From: Ellen Fairleigh
Sent: Monday, February 12, 2018 12:20 PM
To: 'pcwetzal@gmail.com'
Subject: RE: FW: PLN51027 VEG question
Attachments: PLN51027 SPT NOA.pdf

I noticed the posting of the Stahl/St. Louis vegetation proposal that went out today: [PLN51027 VEG](#)

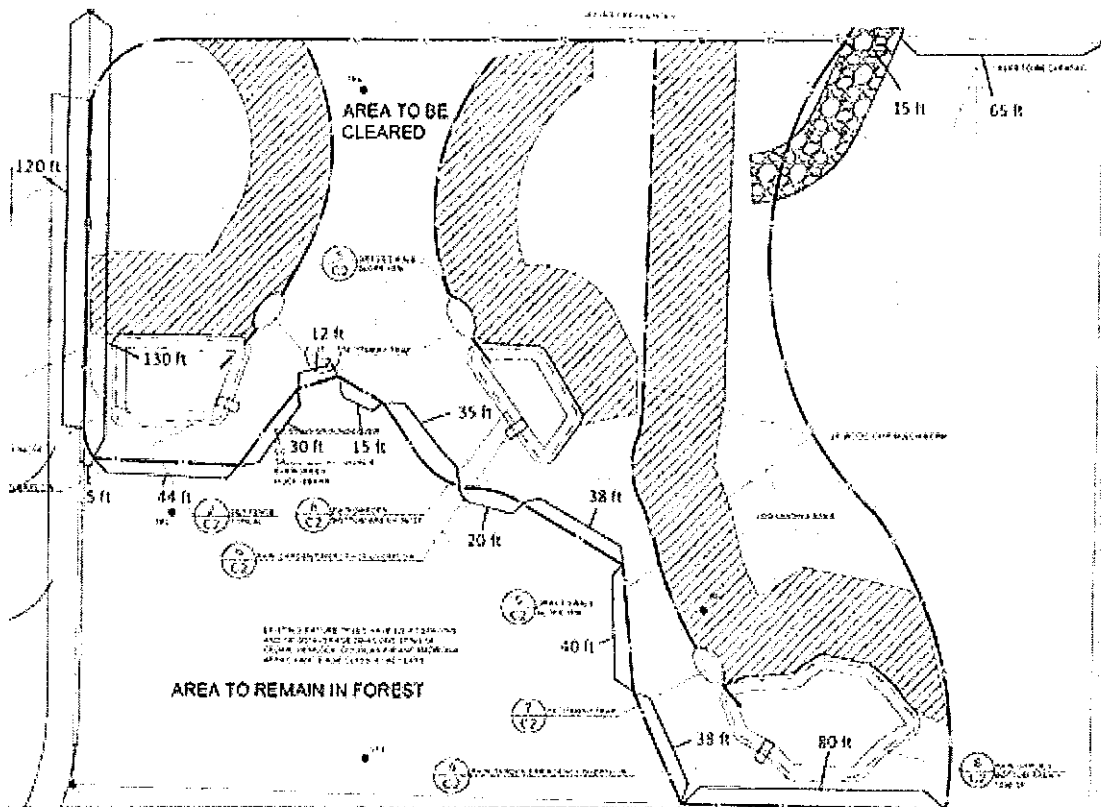
If you don't mind, I had another question. I'm trying to gauge the distances on the clearing map but would like to verify that my measurements are correct. I have attached a image of what I think each distance translates to. If you don't mind, would you be able to please confirm these distances for me?

In Ellen's absence I did some quick measurements on the project file site plan in comparison to the figure in your message below.

Based on the specified site plan scale of 1" = 20', your measurements appear to be correct within 1 – 3 feet, depending on exactly where one starts the scale measurement from. The only measurements where I differed by more than a few feet are along the westerly property line: where your figure indicates 120 feet and 130 feet respectively, I measured 125 feet and 137 feet.

With the above caveats, your measurements appear to be fairly accurate based on the specified site plan scale.

[Preview attachment C1 CLEARING PLAN \(2\).pdf](#)

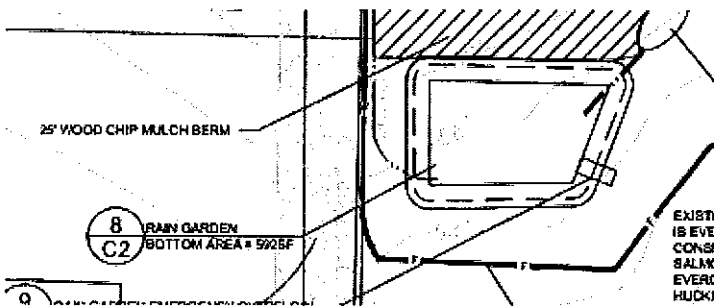
In the Site Map (attached), I'm confused on what all gets cleared. Is it the diagonally stripped shaded area? Or is it the entire area that is delineated by the "Fenced" area? If it is the entire fenced area, what does the shaded areas mean?

The entire area delineated by the fence- the hatched area marked as "F" and "CL" - indicates the area proposed to be cleared. The hatched areas within the delineation is marked as "25' wood chip mulch berm" leading down to proposed rain gardens.
